UNITED STATES
NUCLEAR REGULATORY COMMISSION
 WASHINGTON, D.C. 20555-0001

October 11, 1995

APPLICANT: GE Nuclear Energy (GE)
 PROJECT: Simplified Boiling Water Reactor (SBWR)
 SUBJECT: SUMMARY OF MEETING WITH GE TO DISCUSS CONTAINMENT TESTING ISSUES

FIGURE 3-1. GIRAFFE Test Facility Schematic

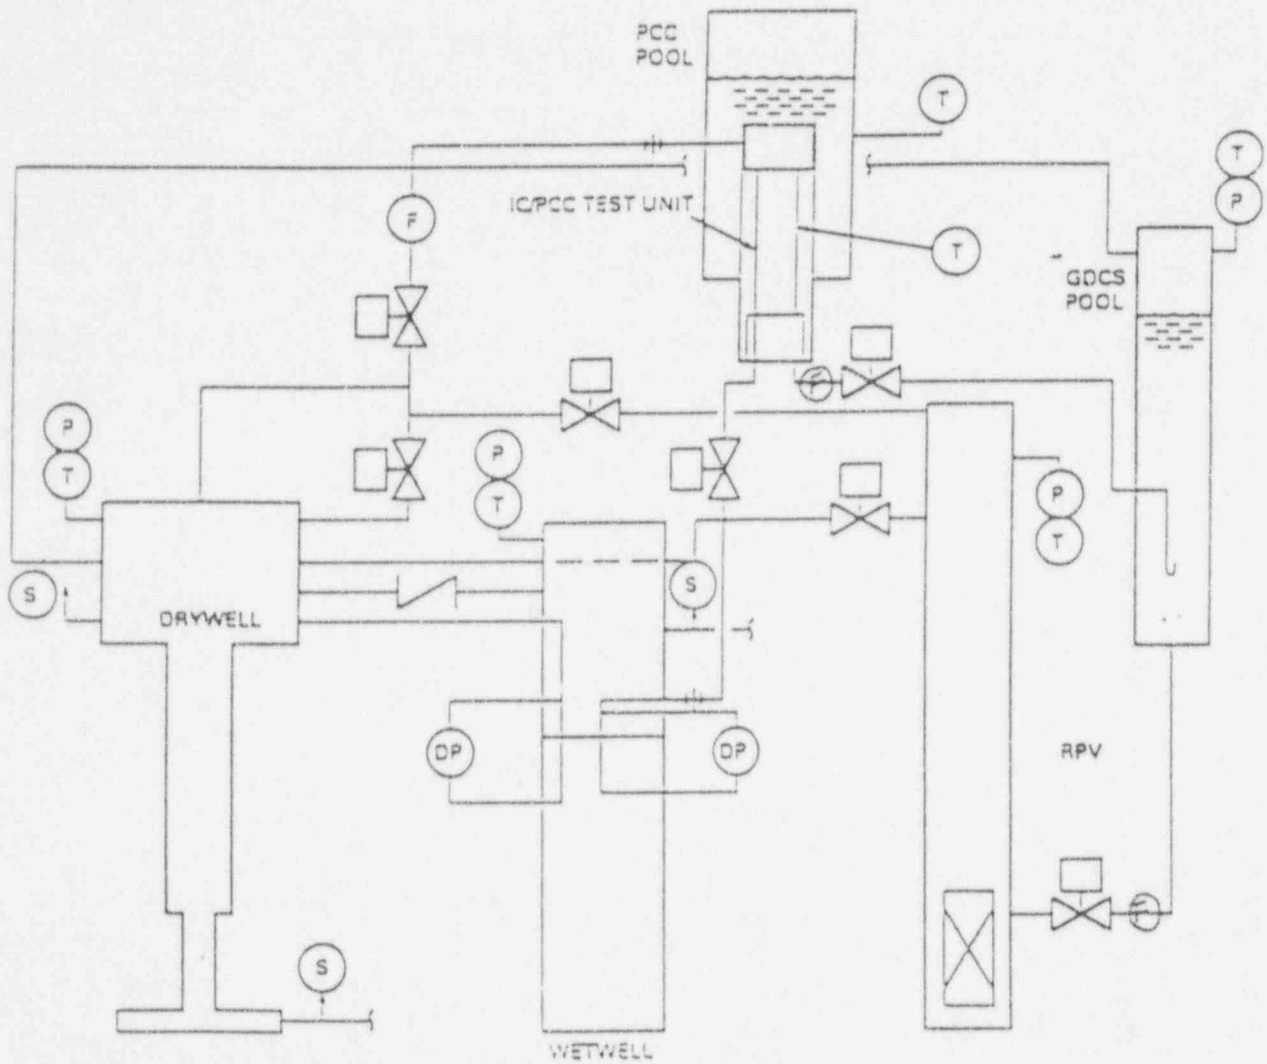
1. GE agrees to modify test objective #3 to remove goal of reinforcing use of data from previous testing.
2. GE will provide clarifications to data presentations:
 - Water vapor weight column in gas sampling measurements
 - Uncertainty in noncondensable concentration measurements
 - Normalization of total sample concentrations to 100 percent
 - Precise definitions of delta-ps in PCC and LOCA vent lines
 - Provide spread in helium concentrations (partial pressures) related to band of temperatures in PCC tubes
3. GE will evaluate GIRAFFE and PANTHERS data for consistent trends with helium concentration.
4. GE agreed to look at thermodynamic conditions in GIRAFFE wetwell to confirm application of microheaters is not overcontrolling the test

- 4. Microheater power in GIRAFFE/Helium tests: GE should provide data (thermal gradients, etc.) to justify that the tests were not overcontrolled to maintain suppression chamber pressure.

Suppression Chamber Microheater Power Adjustments During Tests

- During heat loss tests the microheater power settings determined so that heat losses are completely compensated by microheater power.
- Once the gas venting becomes intermittent, the gas space plenum temperatures are monitored. These temperatures are maintained at a constant value, by controlling the microheater power.
- After gas venting is completed, the S/C pressure should not increase further. The gas plenum pressure is monitored and is maintained by controlling the microheater power.
